水務署
Water Supplies Department

**Approval of "DORNBRAUCH" Bath/Shower Mixer
(General Acceptance No. C20200761)**

Details of Fitting: 1/2" Deck mounted bath/shower mixer with 3 nos. of flexible hoses approved by UK's WRAS under ref. 2005316

13.512.670.XX

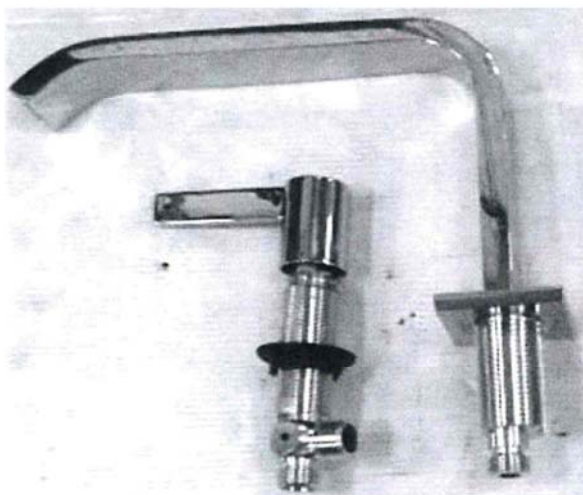
This Authority hereby permits the use of the above fitting in fresh water plumbing systems subject to full adherence to Waterworks installation requirements. In particular, you are required to draw your customers' attention to the following requirement-

"The cold water supply to the fitting shall be drawn from the same source that supplies the hot water apparatus so as to provide a balanced pressure and to obviate the risk of scalding in the event of a restriction or failure in the water supply." AND

"The shower head or handspray should not be placed in submerged conditions and should be securely fixed to the original position after use."
